**CITY OF OAKLAND
COUNCIL AGENDA REPORT**

TO: Office of the City Manager
ATTN: Deborah Edgerly
FROM: Community & Economic Development Agency
DATE: November 18, 2003
RE: A PUBLIC HEARING AND ADOPTION OF RESOLUTION DENYING THE APPEAL OF PLANNING COMMISSION APPROVAL OF MAJOR VARIANCE FOR A SIX UNIT RESIDENTIAL PROJECT AT 436 OAKLAND AVENUE.

RESOLUTION DENYING THE APPEAL AND SUSTAINING THE DECISION OF THE CITY PLANNING COMMISSION IN APPROVING THE APPLICATION FOR A MAJOR VARIANCE TO CONSTRUCT A SIX UNIT RESIDENTIAL PROJECT AT 436 OAKLAND AVENUE, OAKLAND

A4.0

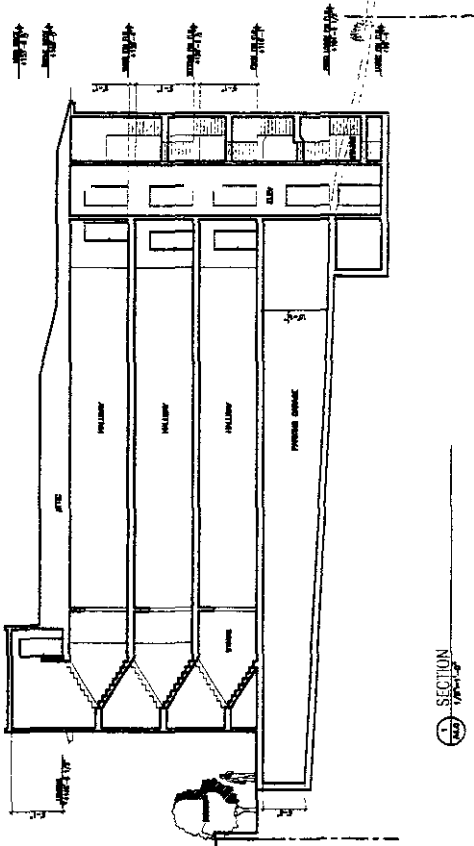
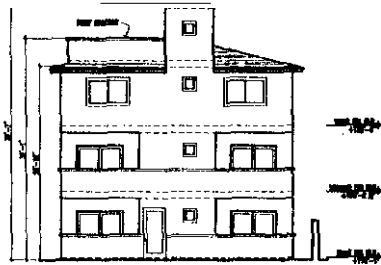
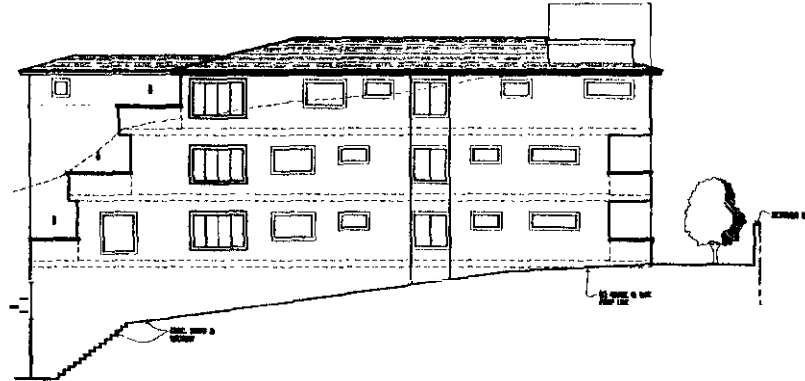
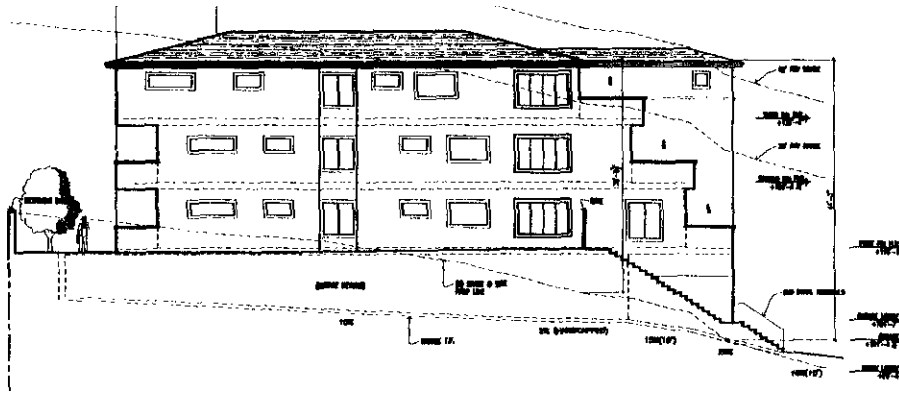
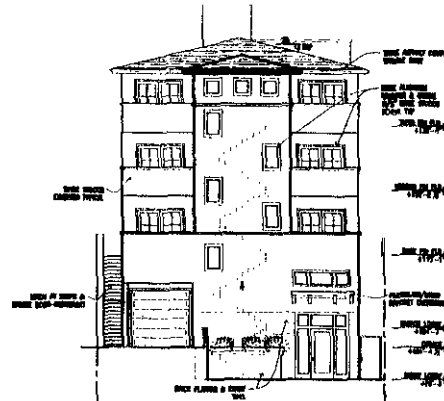
1. The Planning Commission is obligated to maintain views and air rights. In direct violation of this obligation the proximity of the rear facade, the height of the rear facade, rear elevator tower and roof will block views, solar and air access to the appellant's dwelling unit.

*Based upon the documents submitted with the appeal, the appellant's primary concerns relate to the rear facade of the proposed building. The Zoning Code would permit a maximum height of 30 feet for the primary structure. Portions of the building over the 30-foot maximum height are located over 28 feet from the rear property line. Stair and elevator towers are permitted at a height of up to 42 feet, with a conditional use permit required to exceed 42 feet. **only** the elevator and stair tower located **on** the front elevation of the building would exceed 42 feet. The entire rear facade, including the rear 12 feet of the building and the rear stair tower, would be below the permitted height. **In** addition, the structure would be setback 17 feet from the rear property line,*

Staff Response: The current variance findings related to the protection of views and air rights apply to design review for one and two-family residential projects only. This request would provide for a six unit residential project. Therefore, the Planning Commission was not obligated to make specific findings related to the maintenance of views and air rights in respect to this application.

where only a 15-foot rear yard setback is required. Height and setback requirements of the Zoning Code are intended to provide a level of protection for solar and air access between structures. Given that the rear facade of the building, nearest the appellant's dwelling unit, would be below permitted height and that the rear setback of the structure would exceed the requirements of the Code, the view, solar and air right protections intended by the Code have been met.
